ORIGINATION FORM

Proposed Revisions to a Standard Plans Index (Please provide all information — Incomplete forms will be returned)

Index Number: 646-001
Sheet Number (s): ALL
Index Title: NEW: Aluminum Pedestals and Posts -
Pedestrian Detectors and Signals

**ALUMINUM POST AND PEDESTAL MOUNTED
PEDESTRIAN DETECTORS AND SIGNALS**

INDEX	SHEET
646-001	1 of 1

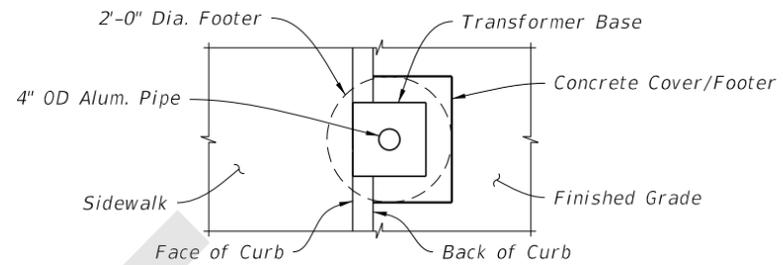
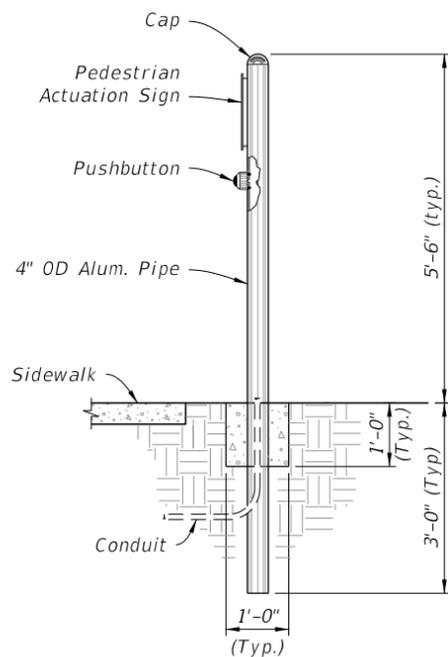
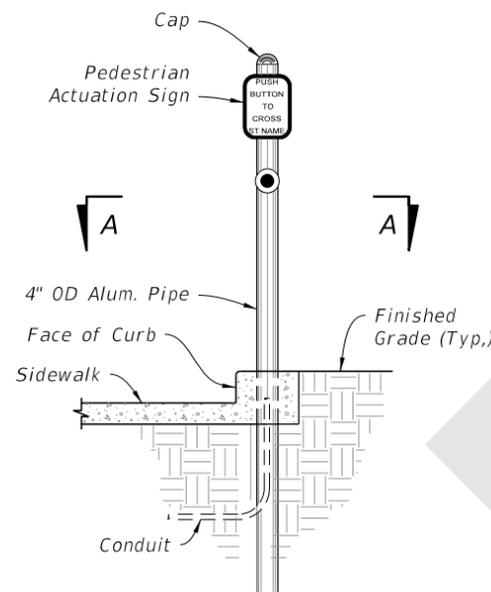
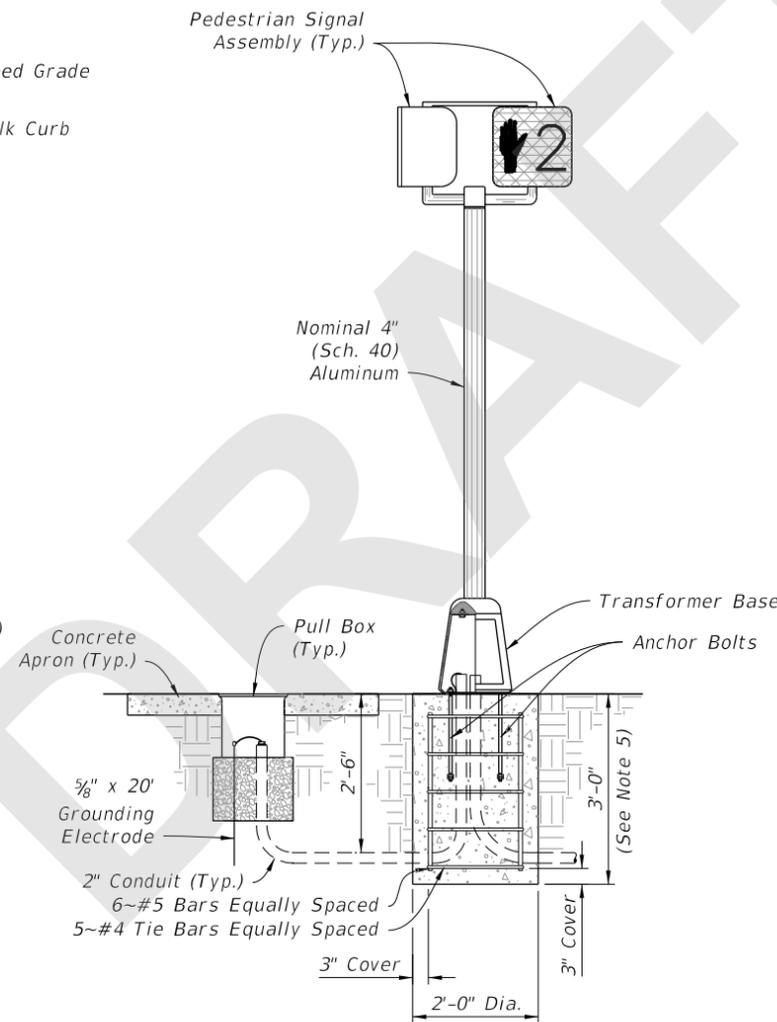
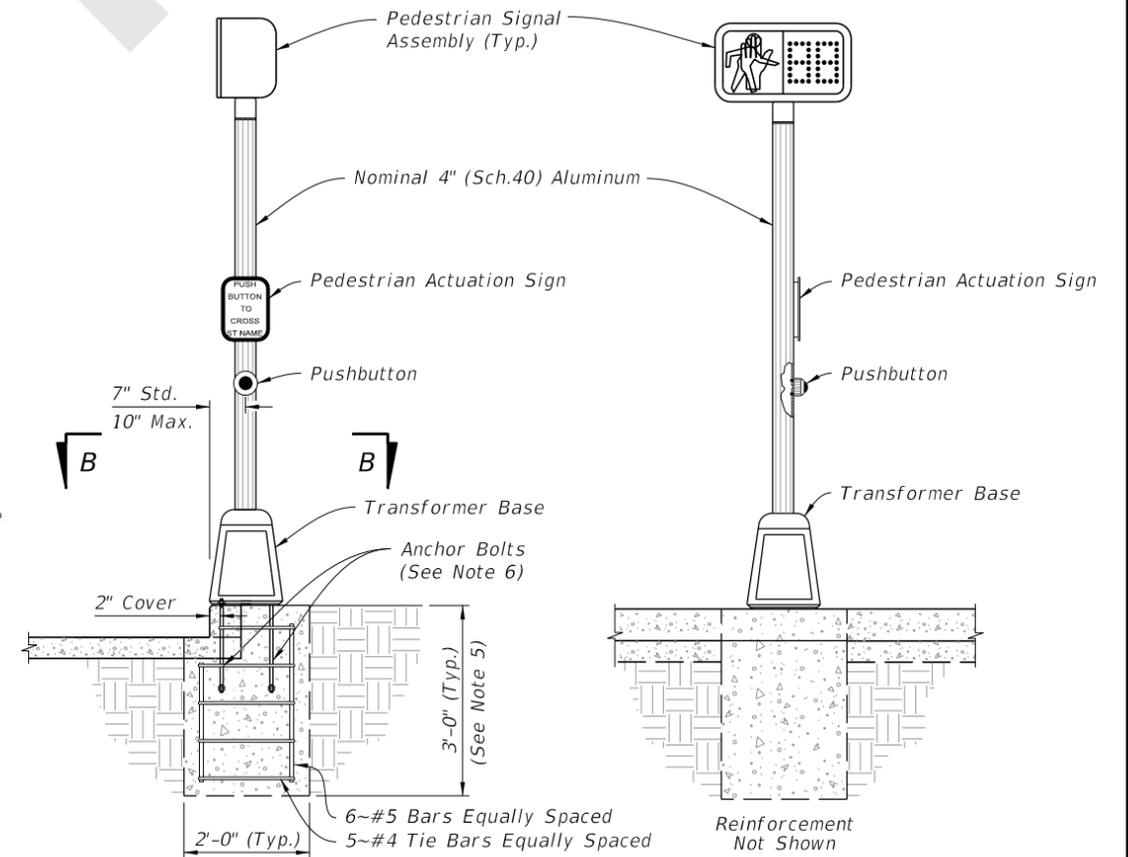
New Index created to consolidate the details of Aluminum Pedestals and Posts used for Pedestrian Signals and Detectors. Existing details are relocated in this New Index from Indexes 653-001 and 665-001. New details have been created to address the foundation and placement details for Pedestals installed with Sidewalk Curb. These were added to prevent pushbuttons from being located greater than 10" from the sidewalk landing.
